**CLEVELAND HOPKINS
INTERNATIONAL AIRPORT
CLEVELAND, OHIO**

Project Title RTA TUNNEL MEMBRANE REPLACEMENT			
Sheet Title SHEET INDEX AND SUMMARY OF QUANTITIES			
Designed: MSI	Drawn: MSI	Checked: LGW	Approved: LGW
Scale: AS SHOWN		Project No.: 198348	
Date: FEBRUARY 2024		Sheet: C-2

2/26/2024 Prebid Questions:

Sheet Title: TUNNEL REPAIR - WATERPROOFING DETAILS

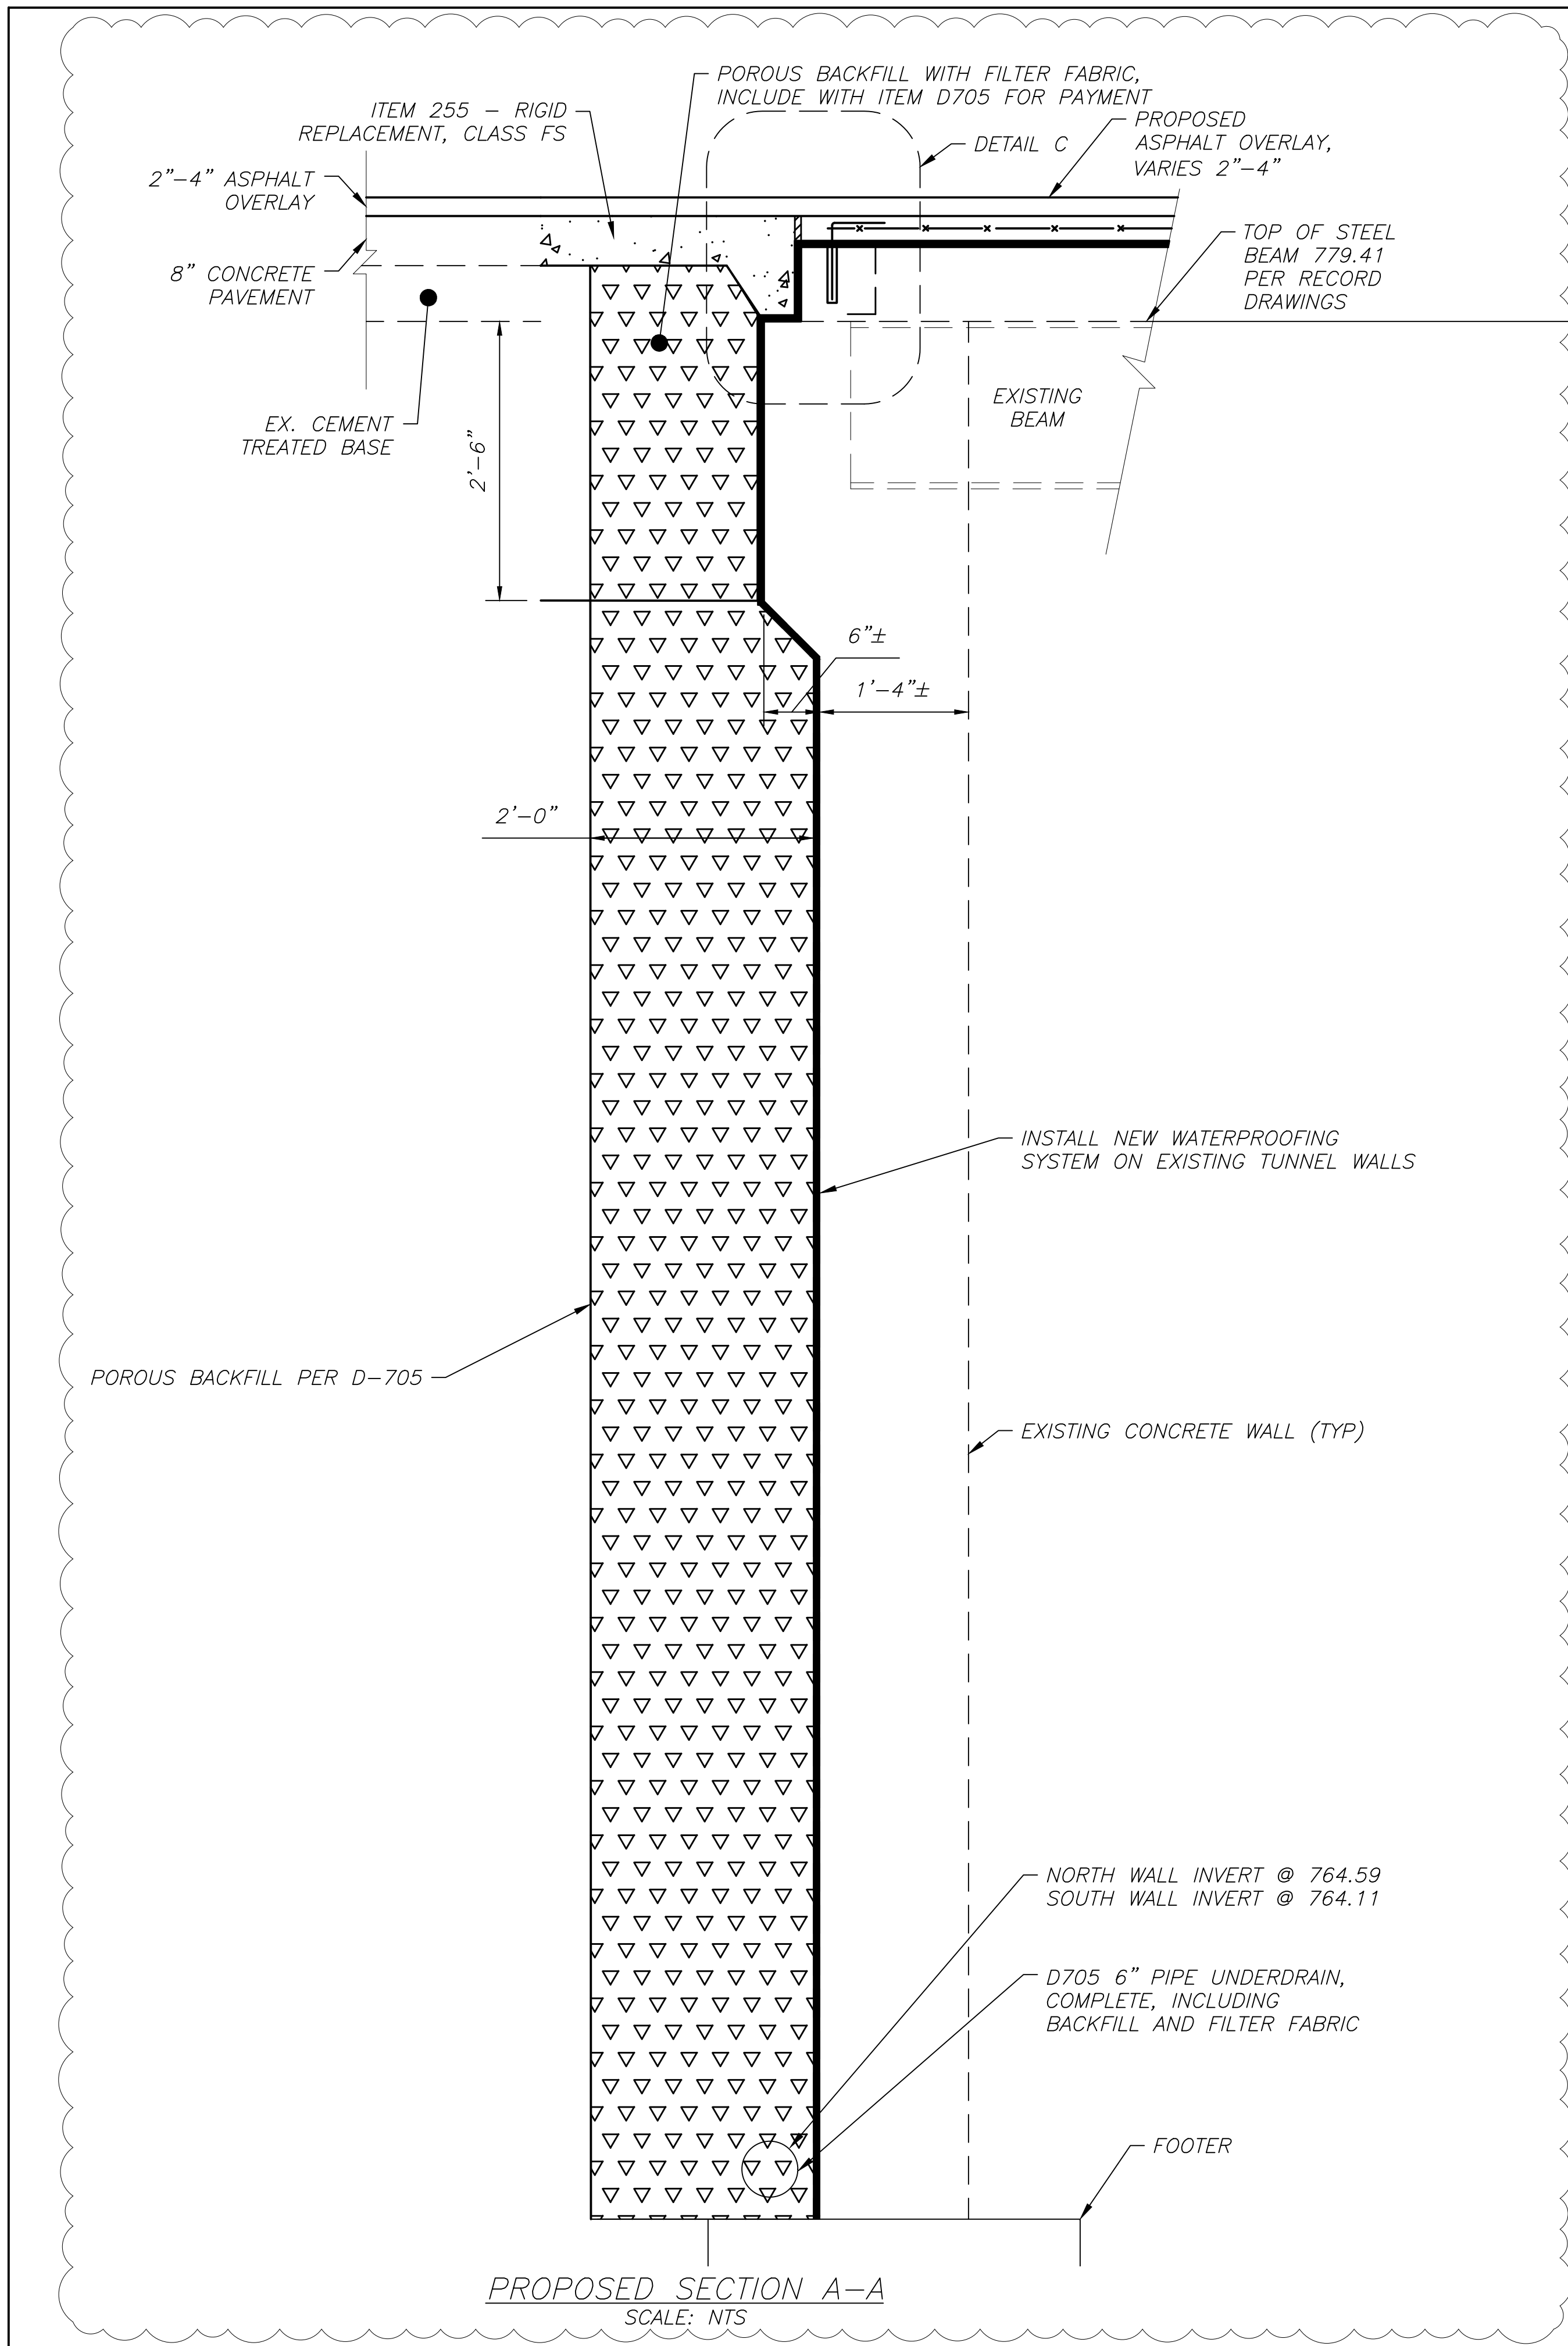
Question: Plan Sheet C-17, Foam Flashing Detail, states to provide "premolded joint material". Please provide specified type and size to be installed.

Answer: The foam flashing detail has been removed. Please see Sheet C-19 for flashing details.

IN-LINE UNDERDRAIN INSPECTION HOLE
NTS

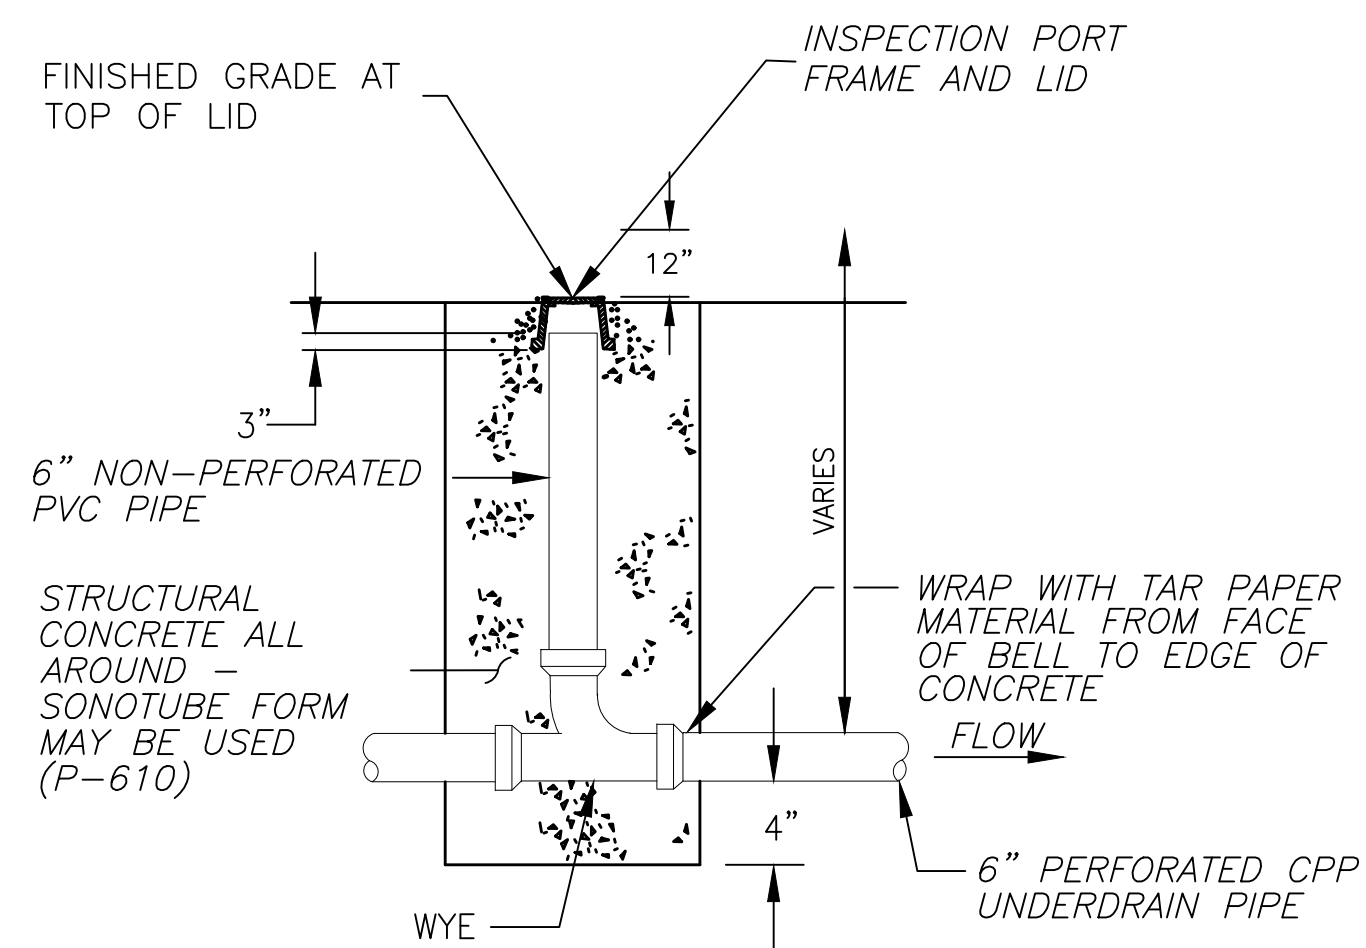
Question: Neither the contract drawings nor Specification D-751 provides any information or standards on inspection holes, nor where they are to be installed. As Item Number D751-5.4 has a quantity of 4 EA inspection holes, more information is needed to clarify this work item. Please provide.

Answer: The Inspection Hole Item will be used on the RTA Connector/Collector level if required. Please see the revised drawings.
